Diablo Canyon
Independent
Safety Committee

Public Meeting
February 21 and 22, 2024

Unit 1 Reactor Vessel Embrittlement Update

- DCISC Embrittlement Consultant's Nine Technical Questions of PG&E
- Answers Provided in This Meeting Are Incorporated into Dr. Kirk's Reports to Be Presented Tonight

NRC Required Analysis for USE

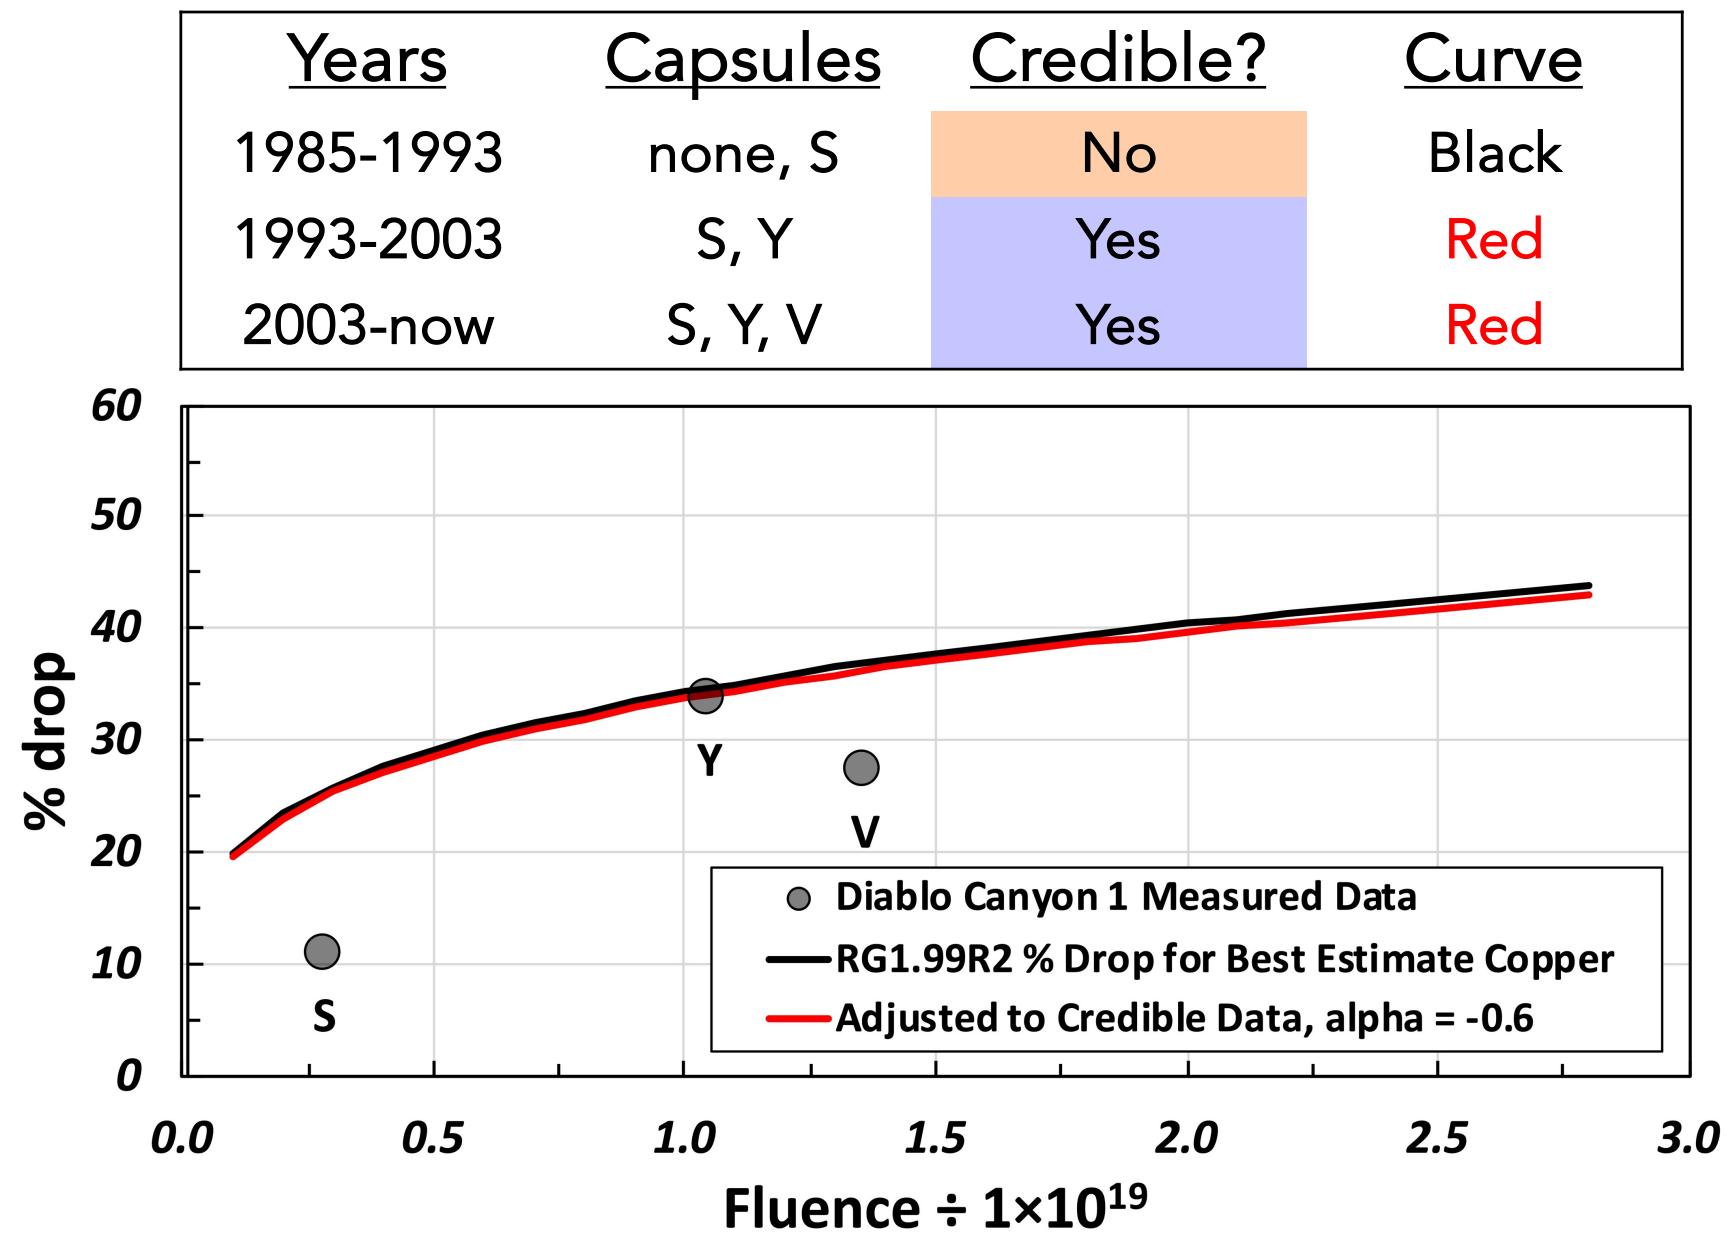
- NRC requires that the RG1.99 model (black curve) be adjusted to bound all credible data (red curve)
 - For Unit 1 the adjustment is minor
- NRC is silent on the use of similar sister plant data for USE assessments
 - USE data from sister plants not typically used

NRC Required Analysis for USE

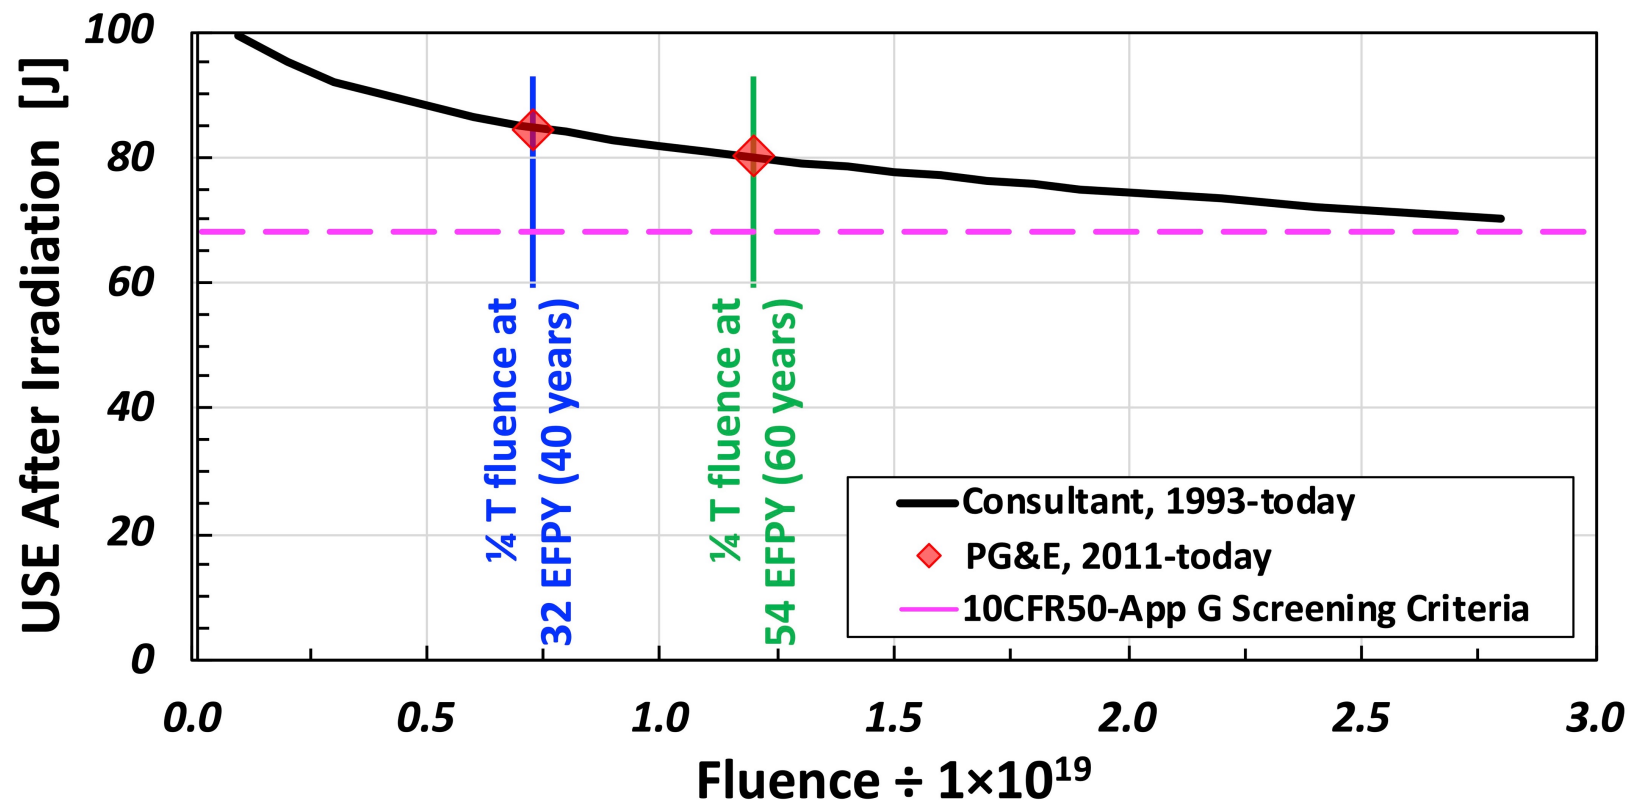
- This analysis suggests that Unit 1 will not fall below NRC's 68J screening criteria until long after 60 years
- My calculations validate those of PG&E from 2011 until today
 - PG&E made a small error in 2003 on credibility assessment for USE. This was identified in an NRC “request for additional information” and corrected
 - Error was in conservative direction. Negligible impact on prediction.

USE

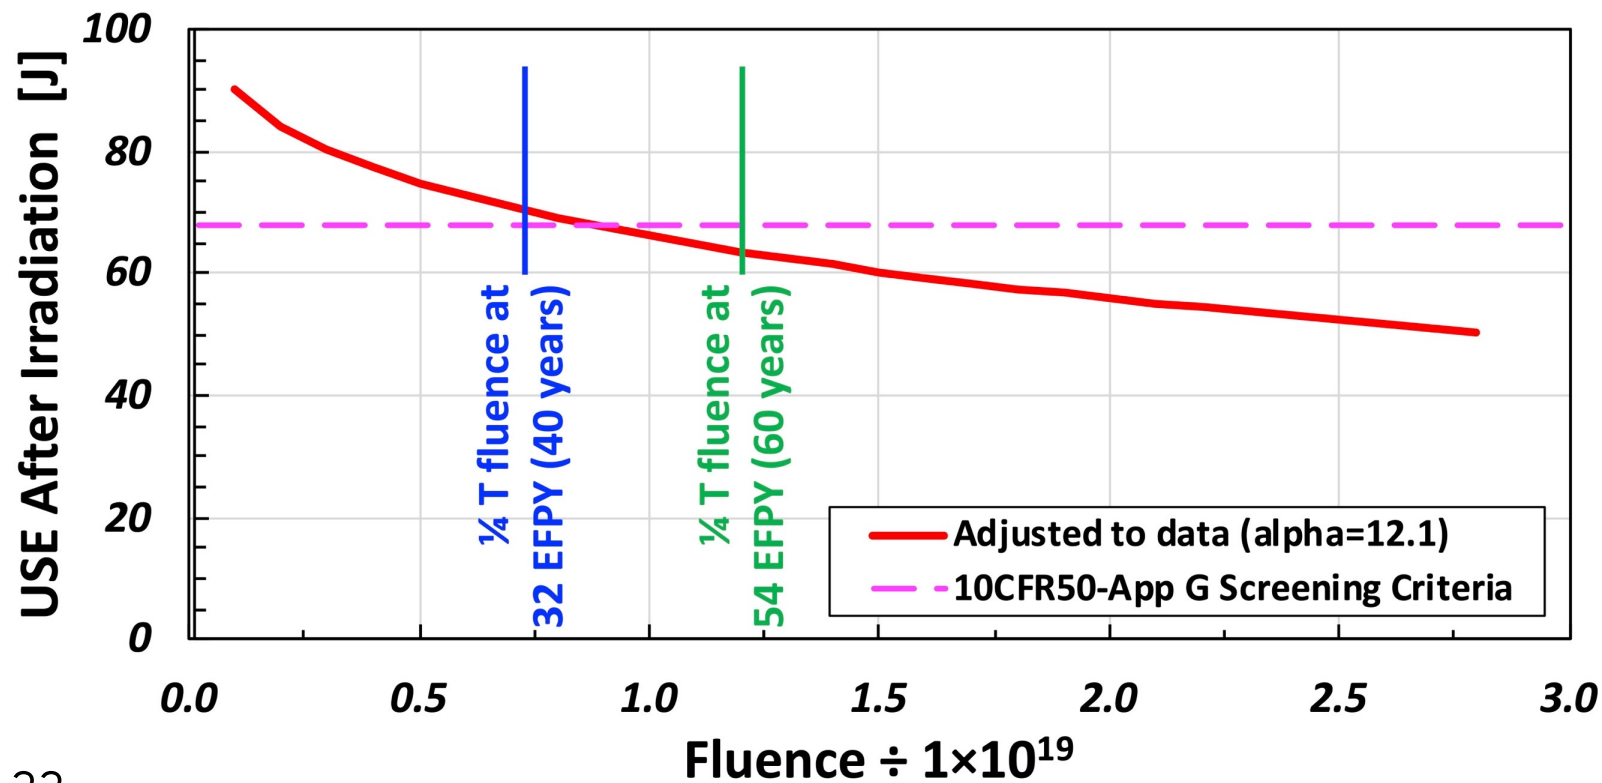
- Consideration of similar USE data & the RG1.99R2 method suggests Unit 1 will fall below the NRC 68J screening criteria before 60 years ($\approx$ 2029-2030)
- This could be addressed by performing an “equivalent margins analysis” (EMA) following RG1.161
- EMAs performed on other plants show, without exception, the acceptability of lower USE values

- Unit 1 may fall below USE screening criteria by $\approx$ 2030
- Further analysis using RG1.161 very likely to demonstrate acceptability through 60 years
- Screening criteria are not failure conditions

Concern

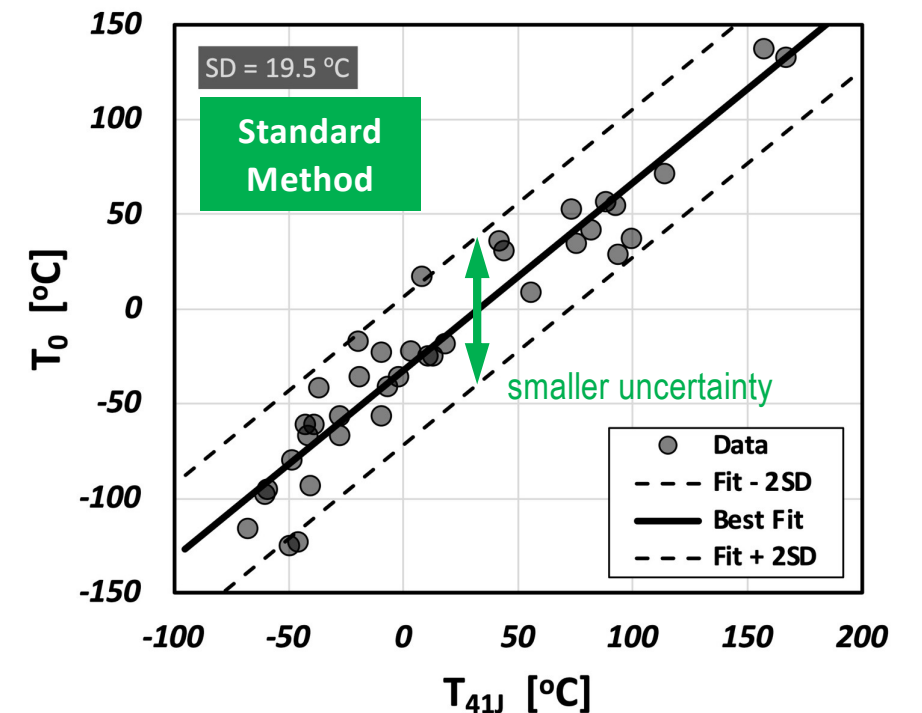
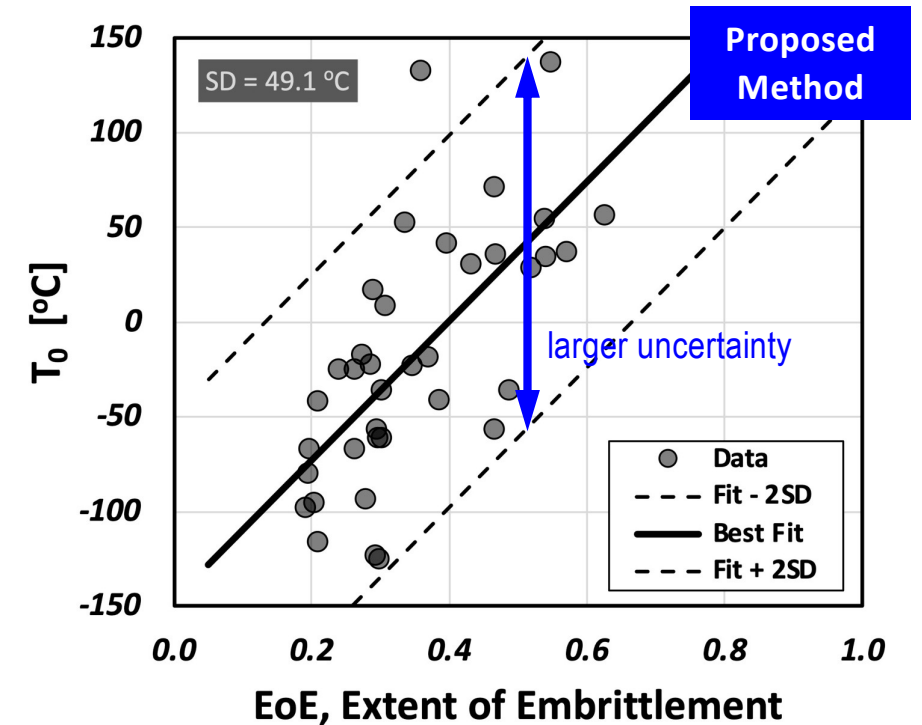
- Proposal to use Nano-Indentation data to further investigate the embrittlement status of the Diablo Canyon Unit 1 weld samples
 - Technique developed by Prof. Hosemann at UC Berkley
- Prof. Hosemann's work is well documented in the literature
 - Hardness can be related to fracture toughness using multiple correlations
 - Hardness $\rightarrow$ strength
 - Strength $\rightarrow$ fracture toughnessEach correlation introduces uncertainty to the final predicted value.
 - No precedent exists for using fracture toughness inferred from hardness in regulatory decisionmaking
 - Lack of precedent and compounding uncertainties complicates interpretation of any data collected
 - If supplemental data are needed, direct fracture toughness (T_0) testing using the “mini-CT” specimen & ASTM E1921 for which there is regulatory precedent would produce clearer outcomes

Concerns

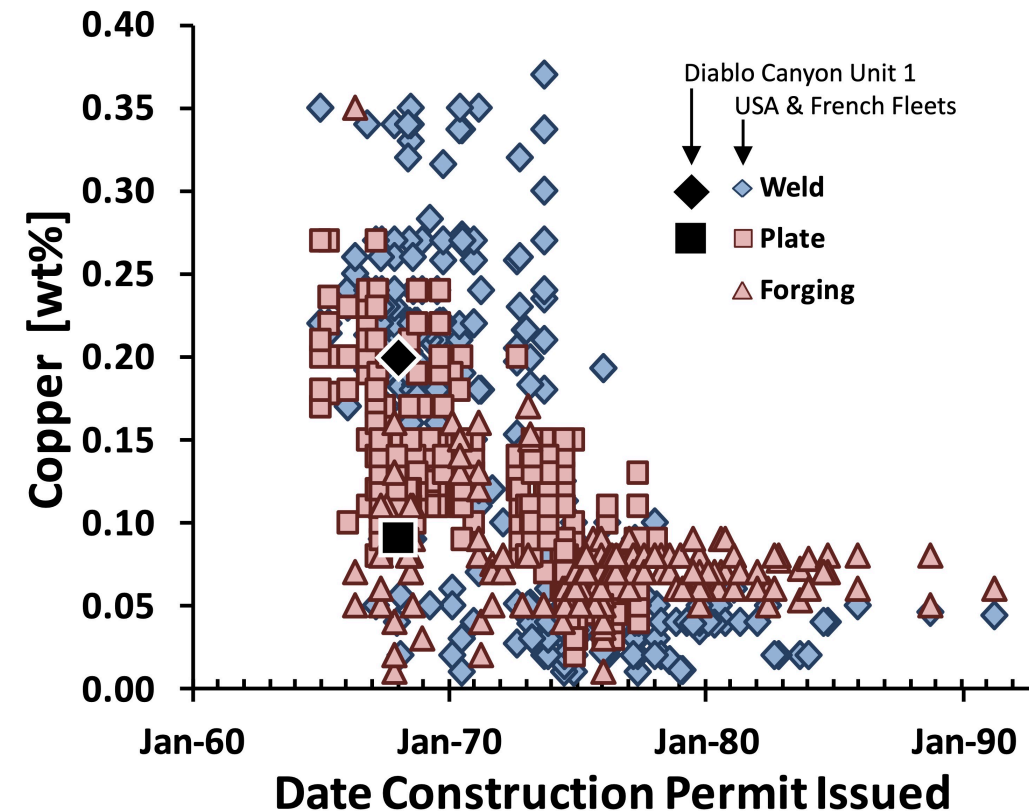
- “Why has no account been taken for the stainless-steel **liner** in determining the susceptibility of the RPV to brittle fracture & hence a LOCA?”

- “Why has no attention been given to low temperature thermal **annealing** of radiation damage”
 - “there were still concerns expressed by PG&E ... regarding the **nozzle** shell welds [who admitted] ... that the nozzle shell welds and related components may not meet fracture toughness limits through the entire 20-year extension”
